Title: 702/720 East Washington Avenue Mixed-Used Development (Working Name)

Re: Letter of Intent – Façade Design Progression
Project: 702/720 East Washington Mixed-Use Development (Working Name)
JLA Architects Project #W22-0106

The items listed below and outlined on the included elevations are design progressions the team has made for the new 720 Mixed Use Building. This package outlines the changes between the previous approvals and the proposed plans.

A202

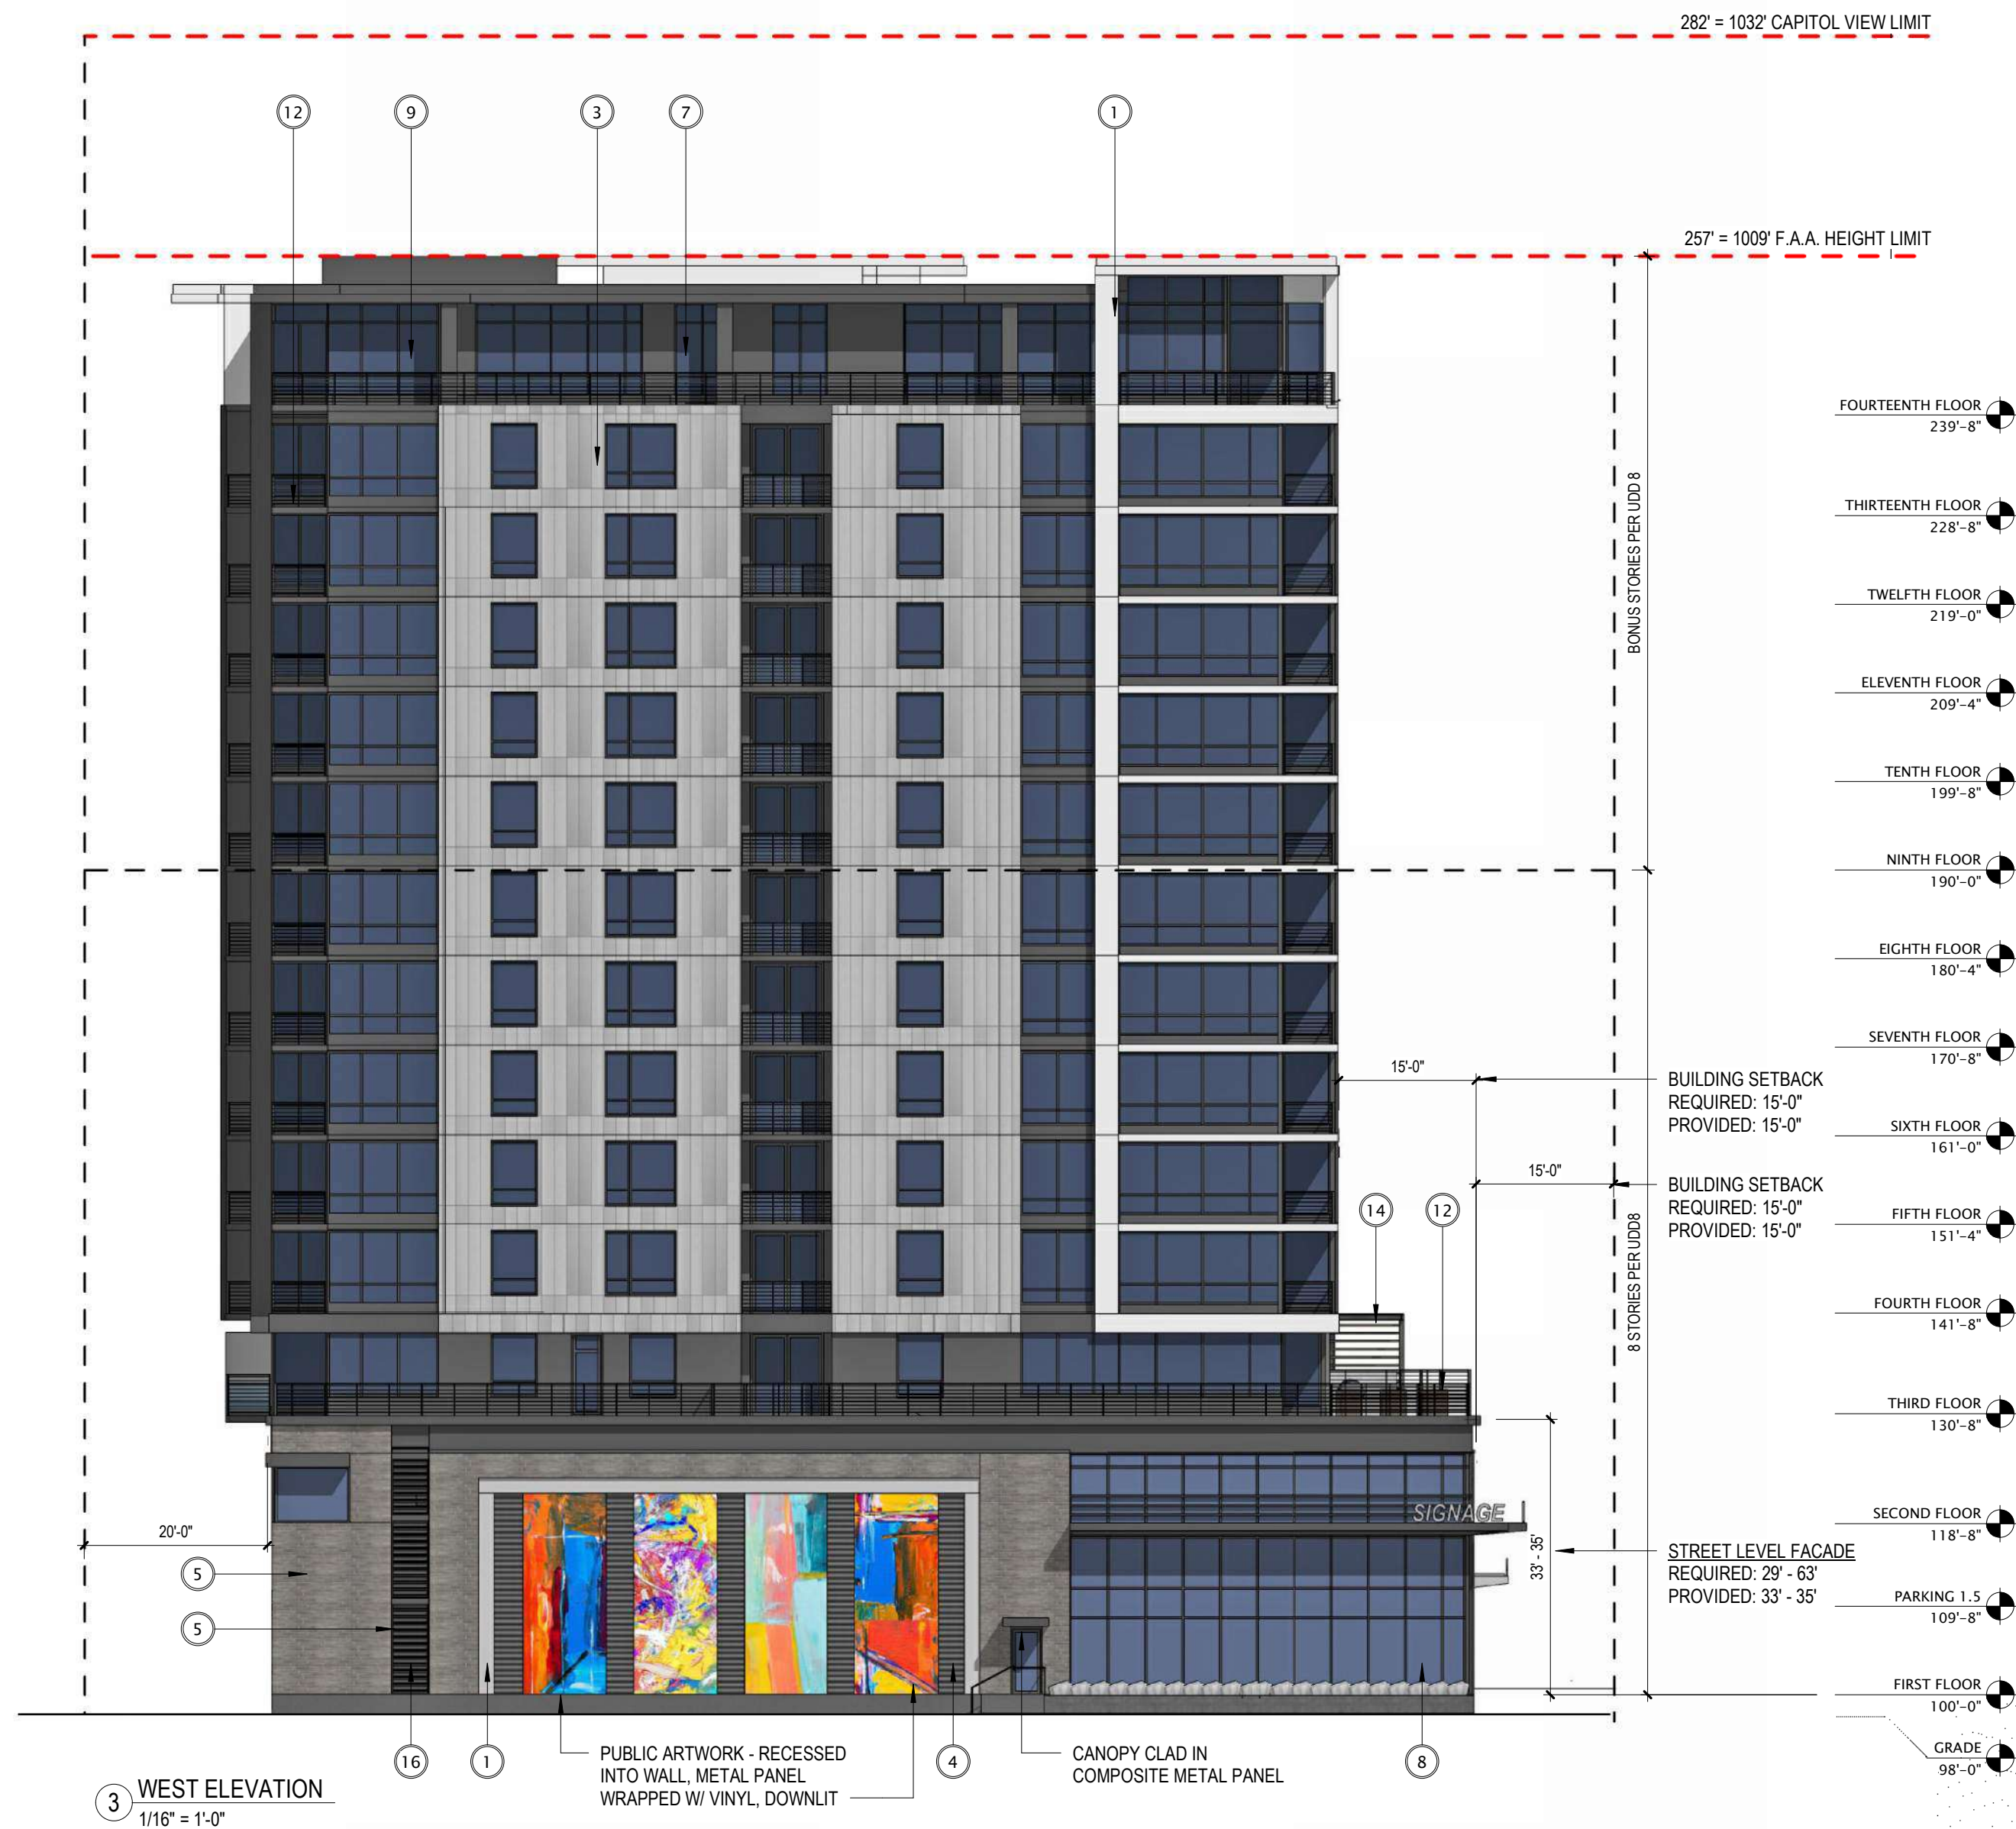
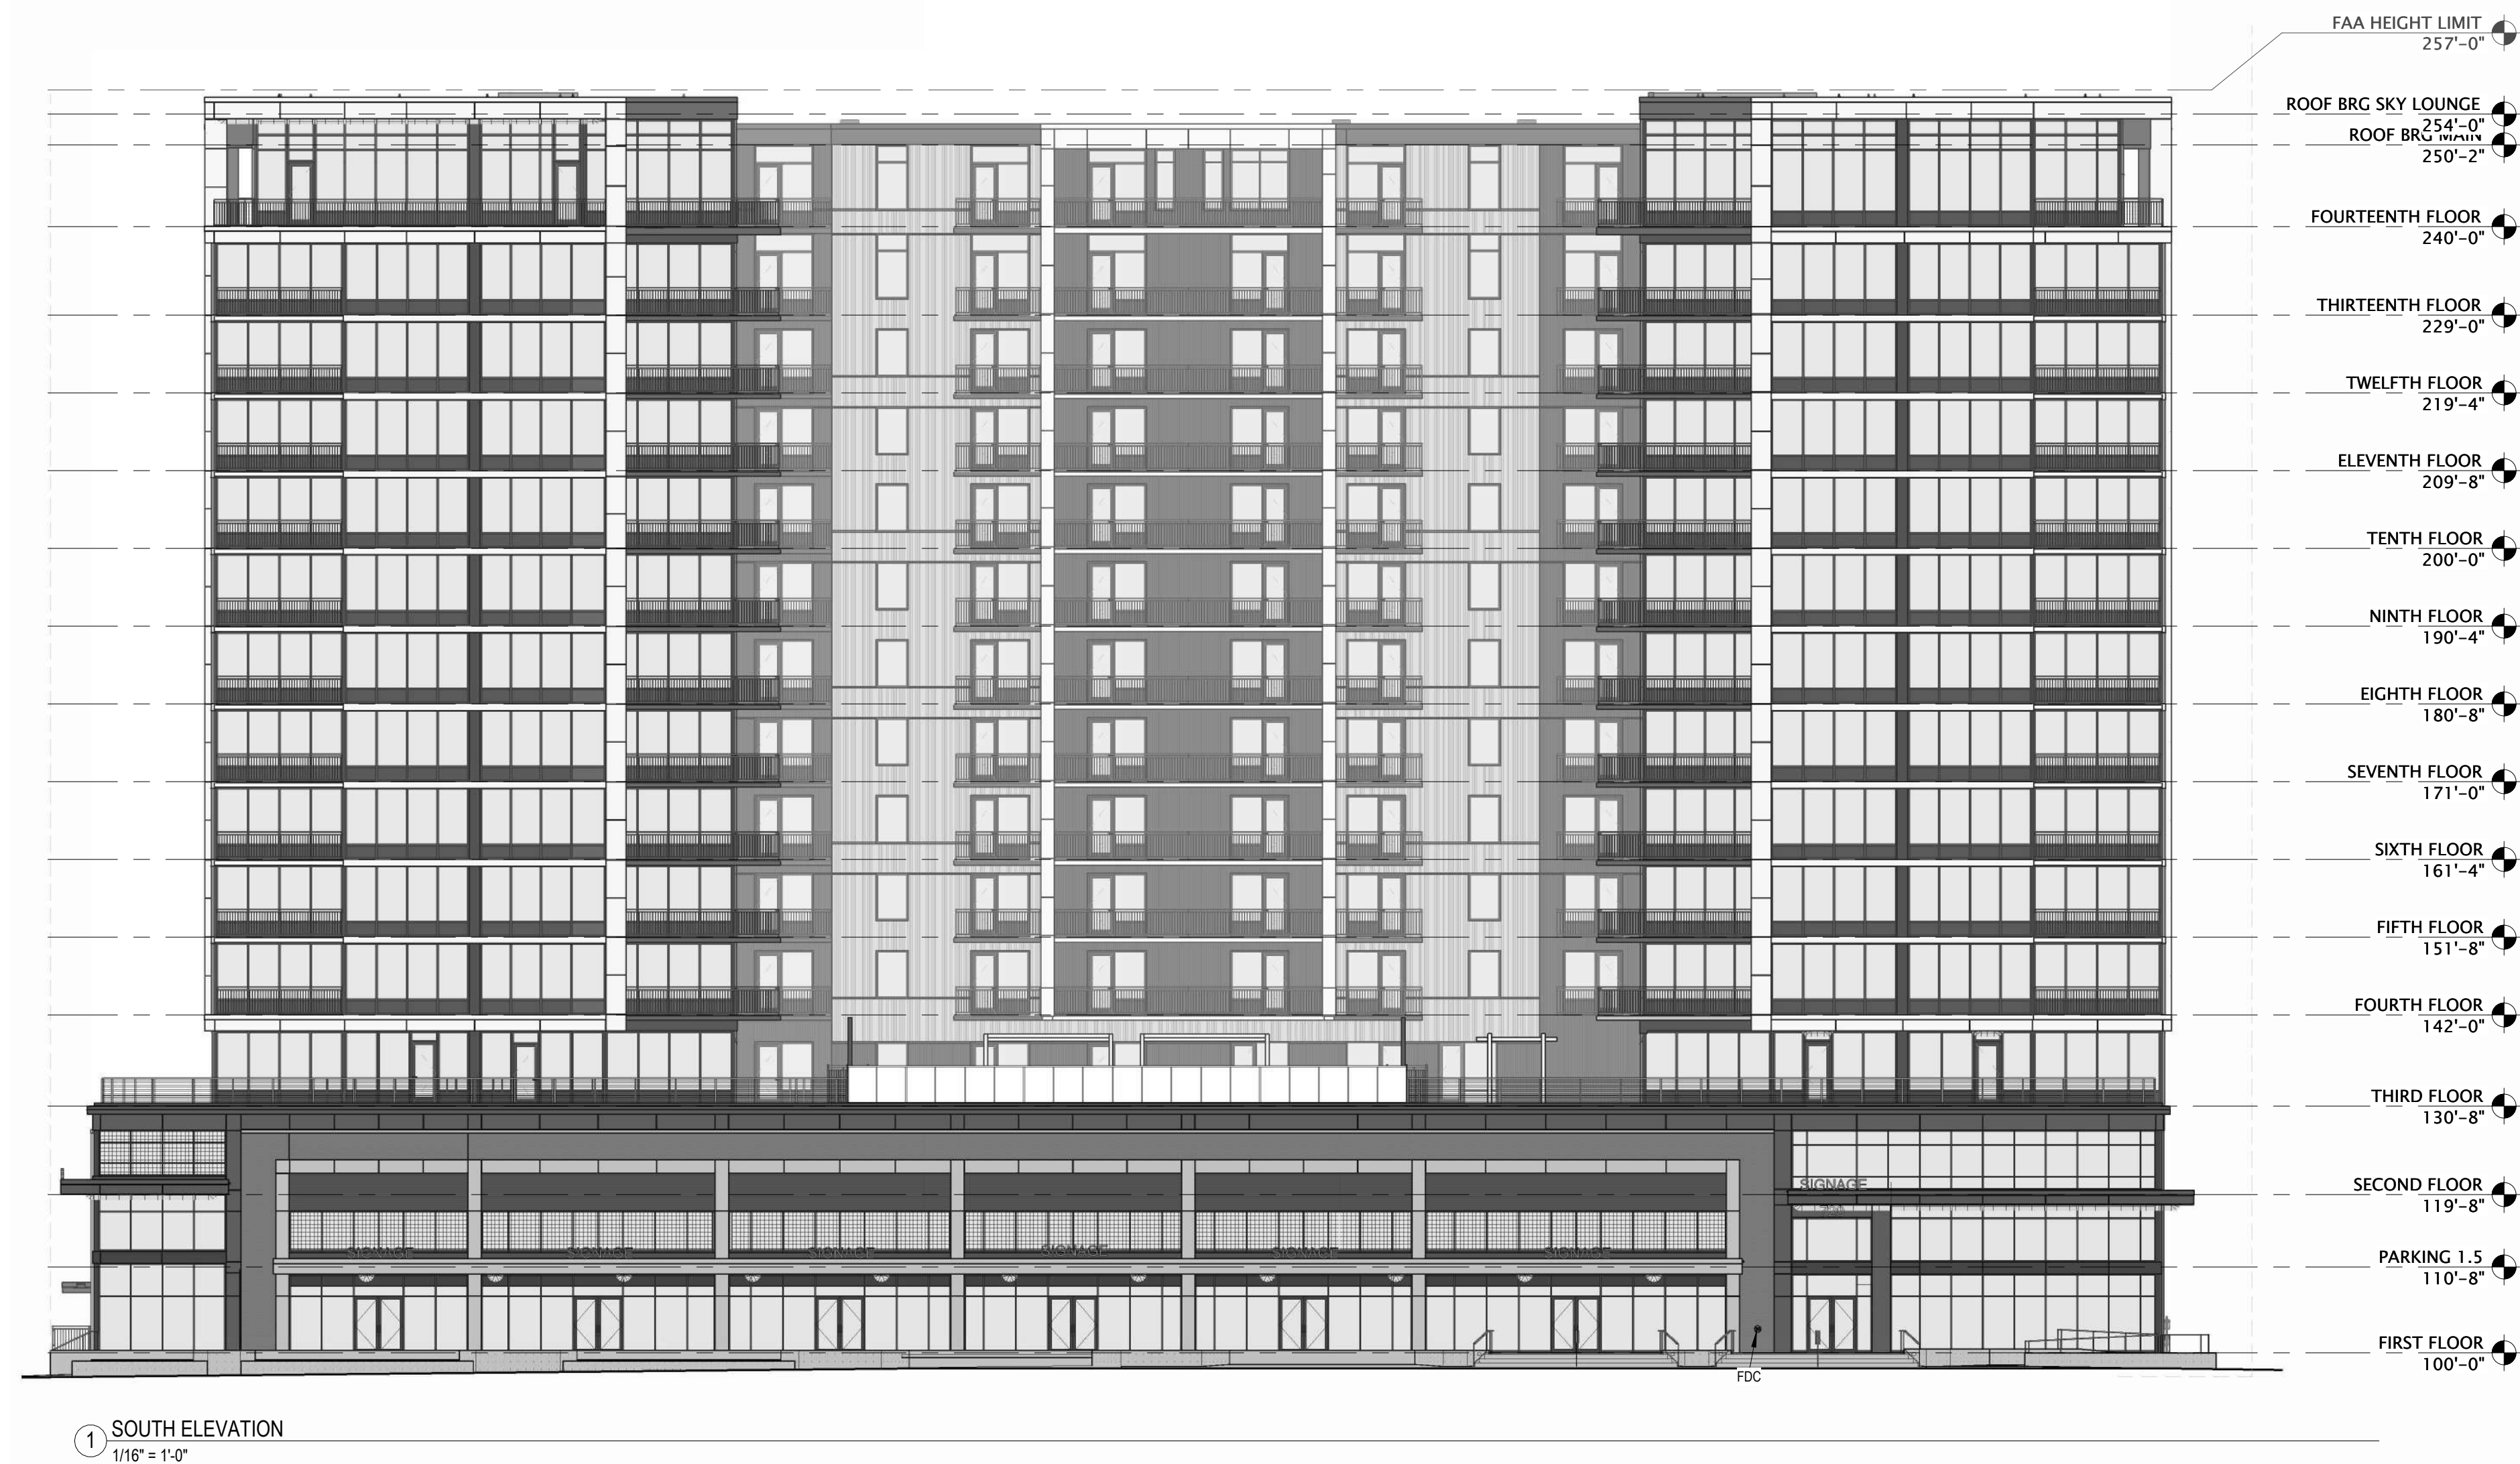
15. Added double doors and louvers on the north and west elevations –
 - a. MG&E requires this electrical vault room on the corner of our building. The double doors are mandatory in these exact locations and the louvers are required as well.

17. Removed one "column" of recessed balconies on the east and west elevations
 - a. These were removed to allow the units a more rentable layout.

19. Removed windows on the East elevation

- a. These windows were removed because they aren't needed at the movie theater.
